**Elan-Santa Monica Place Senior Assisted Living/Memory Care  
6901 San Vicente Ave. NE  
Request Permanent C.O. - Accepted  
Engineer's Stamp dated: 10-16-15 (D18D054B)  
Certification dated: 2-10-17**

## DRAINAGE AND TRANSPORTATION INFORMATION SHEET (REV 09/2015)

**RE: Santa Monica Place (Senior Assisted Living/Memory Care)  
East End of Tract 3  
Grading and Drainage Plan  
Engineer's Stamp Date 10-16-2015 (File: D18D054B)**

# DRAINAGE BASINS

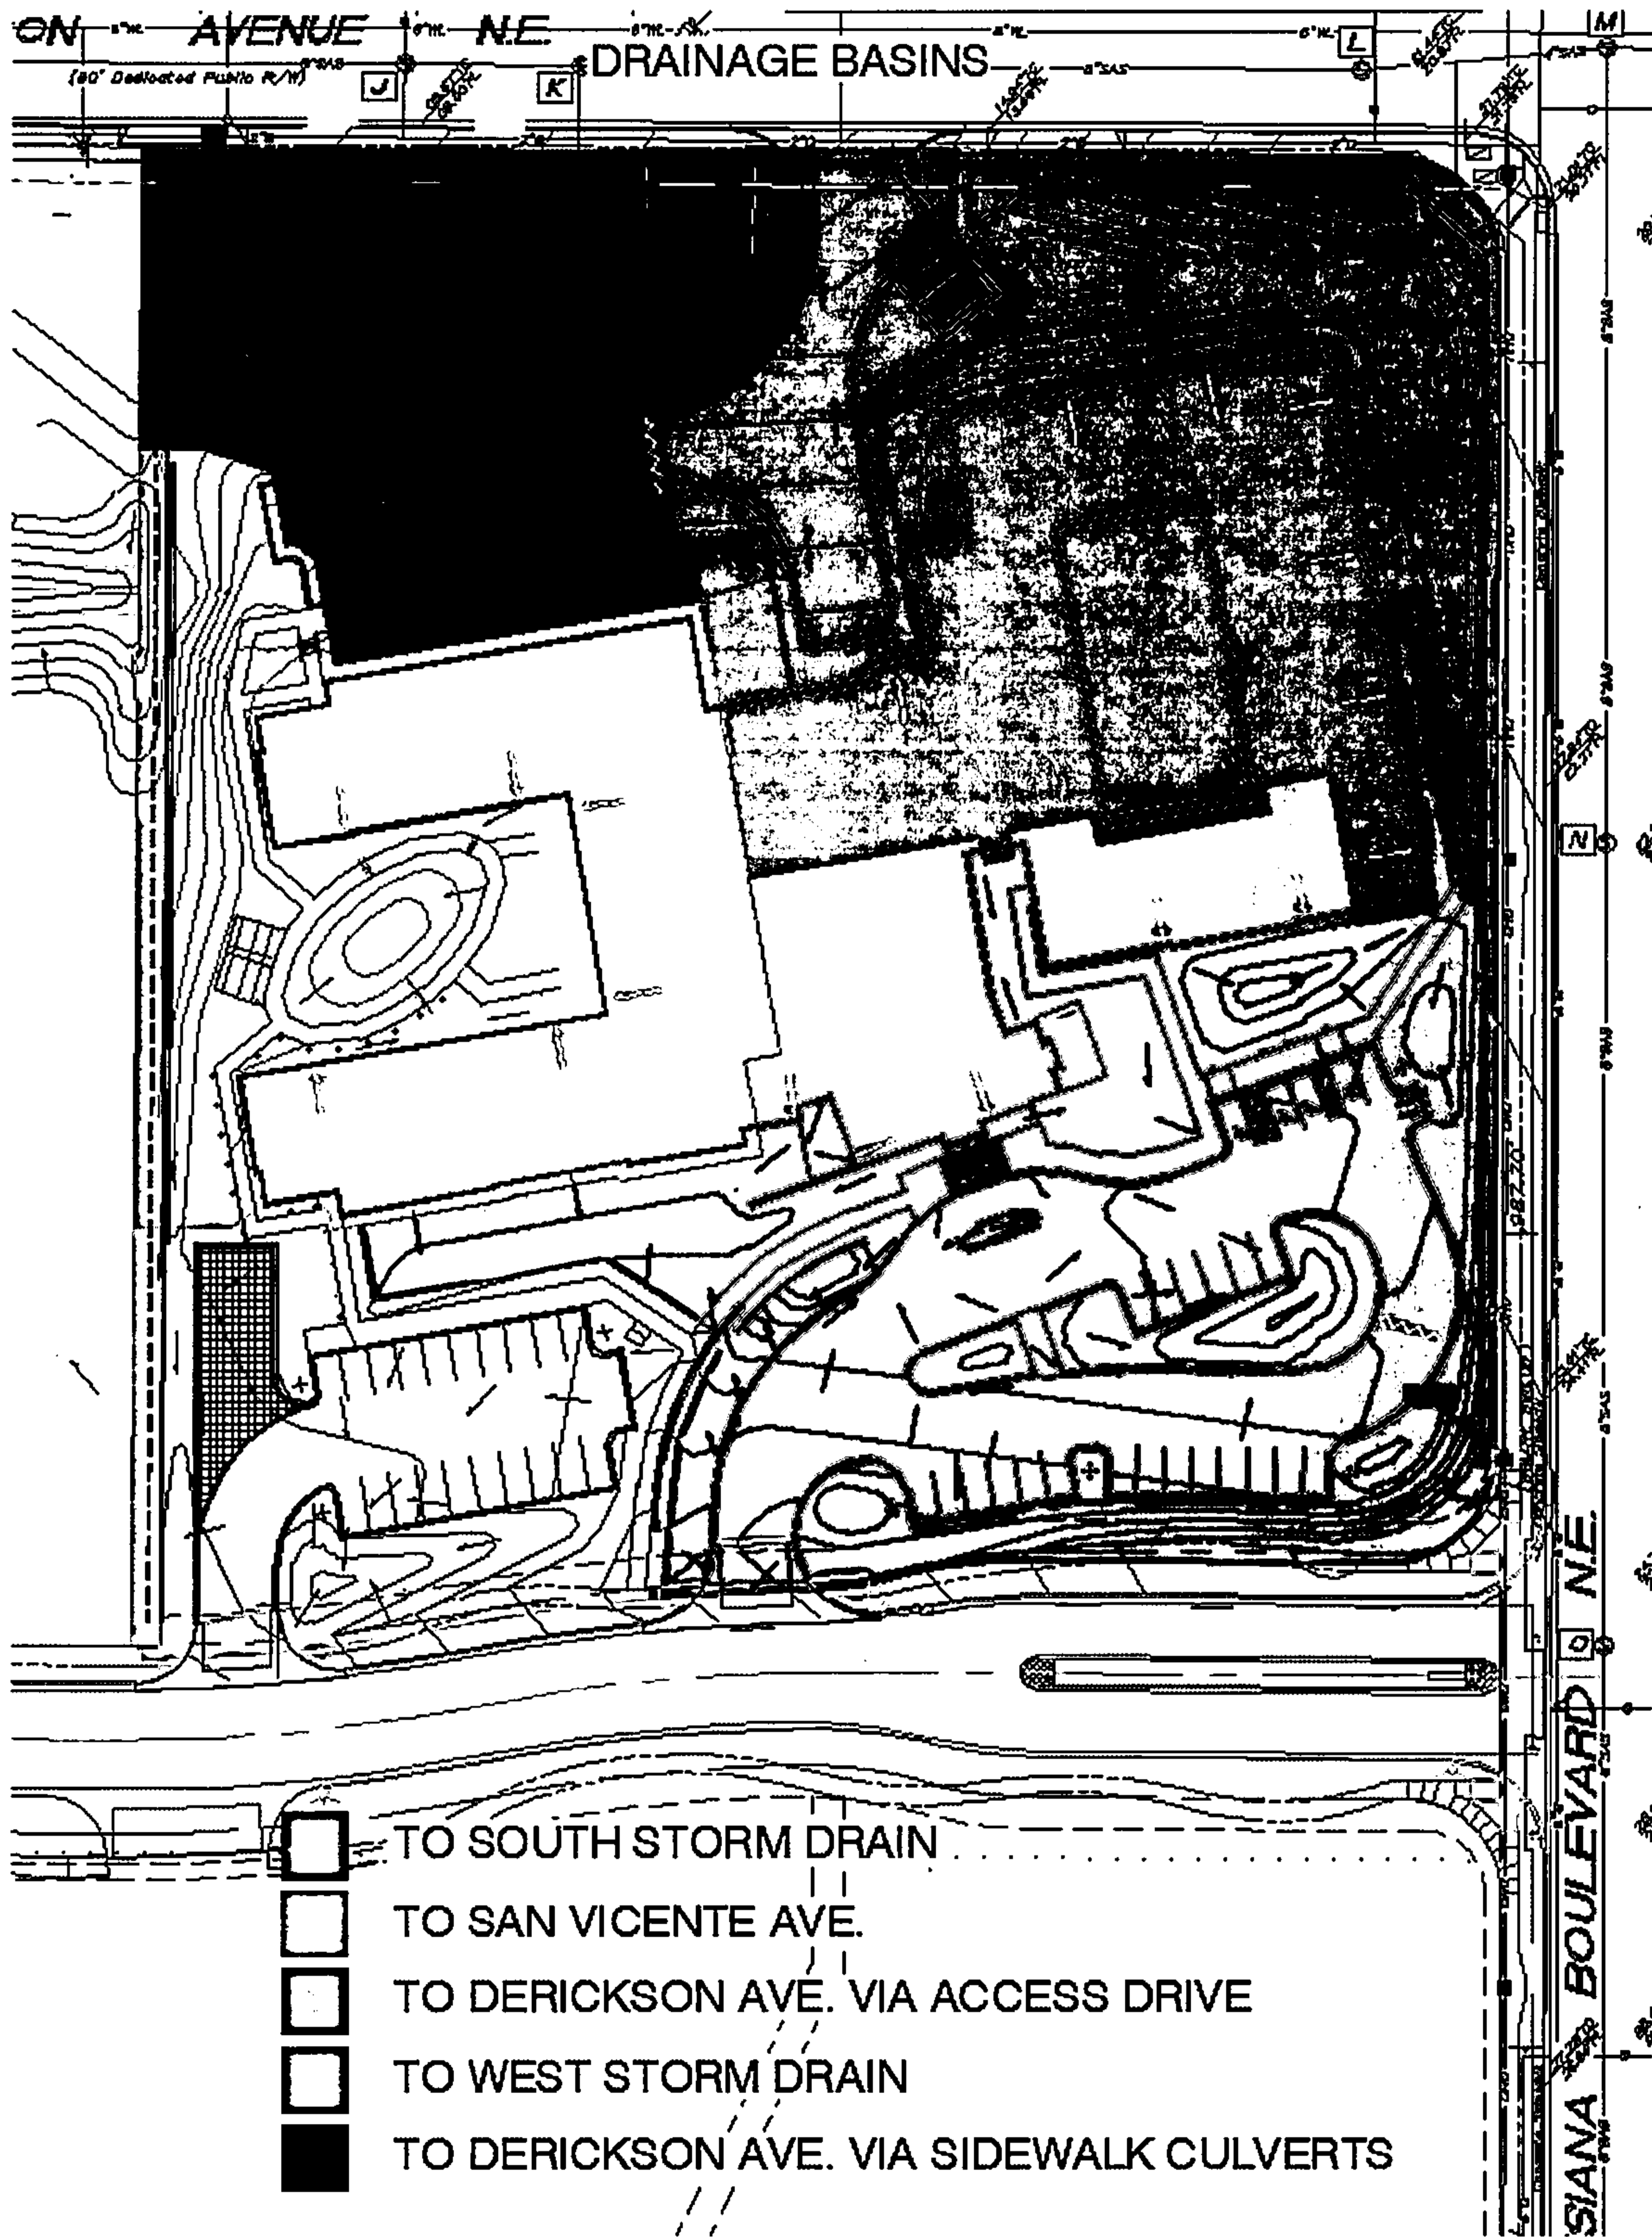
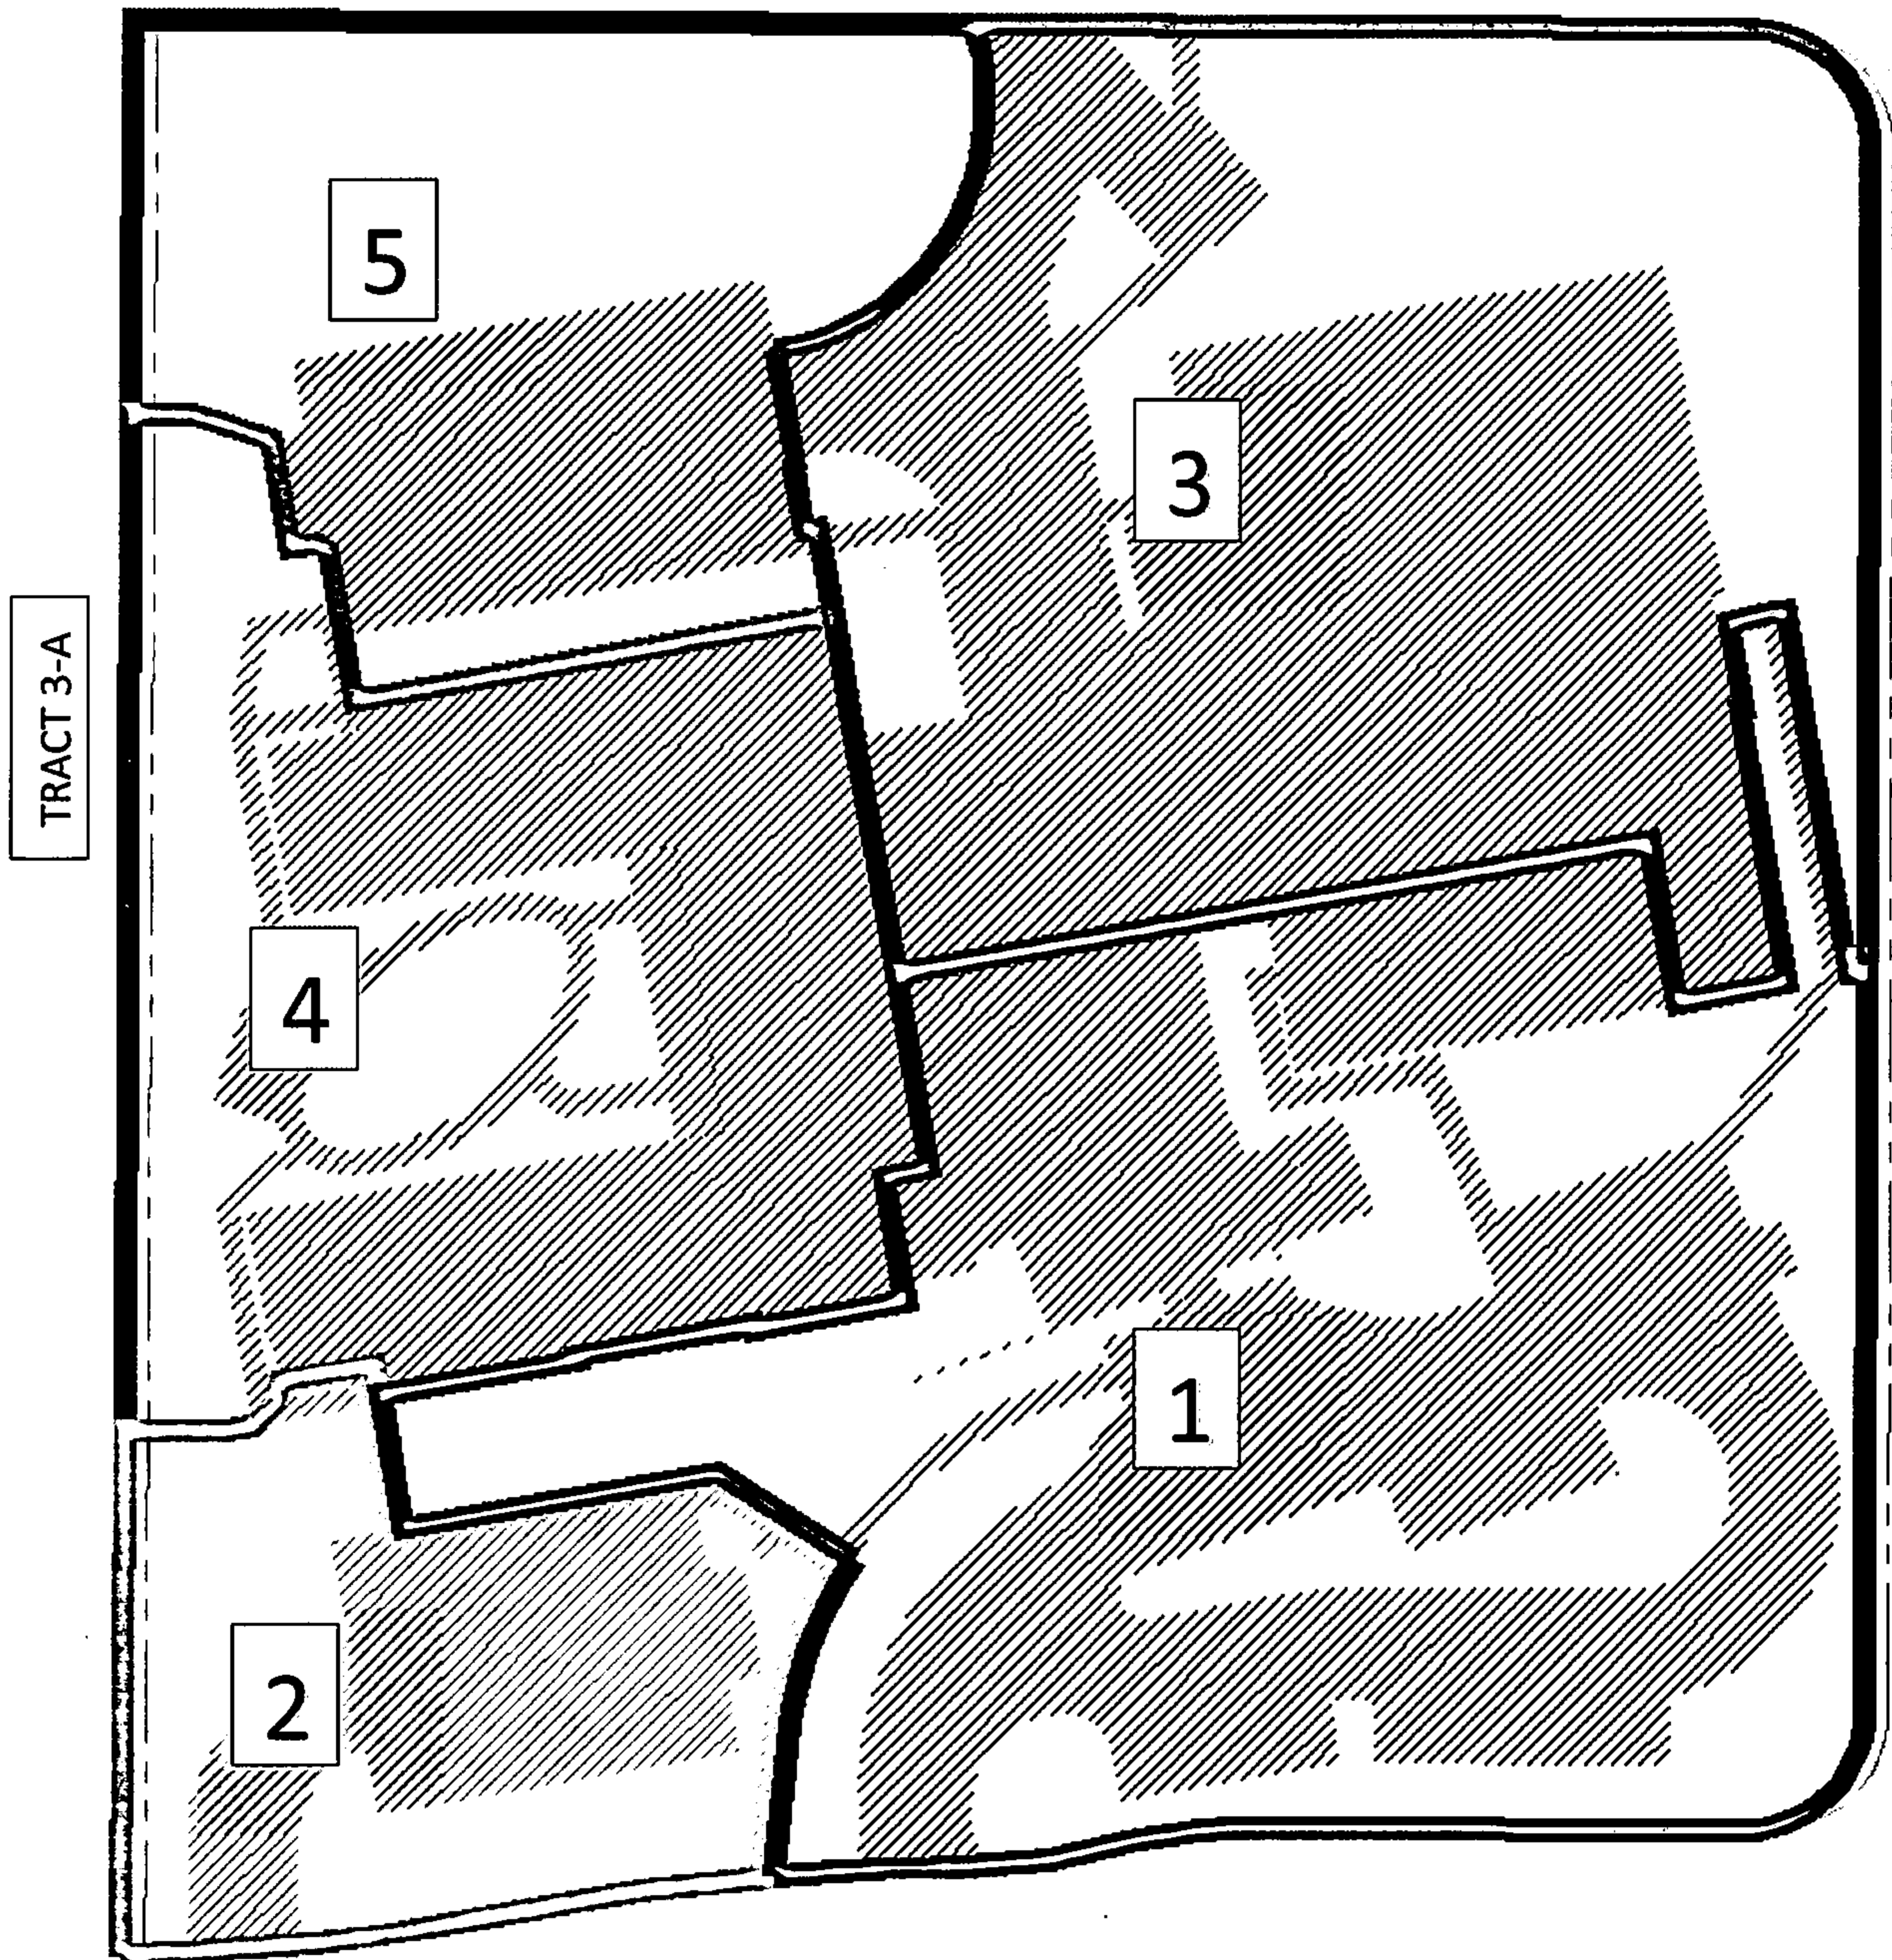
- Roof flows must go through a pond before entering the storm sewer system. ✓
- The pond on the west side of the building contains three different points of accepting flows which are not identified. The pad to the west of this pond, is this the emergency overflow? Provide a profile.
- Plan CG-502 shows a percolation pit, is this being used and where is it located?
- Provide a profile for the 24" RCP penetrating the retaining wall/s headed toward the temporary bubble up outlet.
- Provide the work order number and a detail for the three sidewalk culverts in Derickson Ave. Call out COA specification.

Attached with this letter is are two copies of the revised grading and drainage plans and supplemental information packet for your final review. Revisions were made based on your review comments dated June 24, 2015 as follows:

- All roof drains will discharge at grade and pass to first flush retention basins as shown. ✓
- The covered sidewalk culverts have been identified with Keyed Note 21. Once the shallow first flush volume fills, the excess will pass west via the westernmost covered sidewalk culvert. ✓
- C • Percolation trenches have been added to the first flush basins. ~~████~~ ? ✓
- C • See Sheet CG-502 for a profile of the 24" RCP penetrating the proposed retaining wall.
- The three covered sidewalk culverts will be constructed as part of this project. An S.O.19 block is provided on Sheet CG-101. *ok*

In addition to those revisions, the overall building has gotten smaller and the main entrance has shifted west. This has enabled us to revise the storm drain system and adjust grades. The updated storm drain calculations are provided in the supplemental packet.
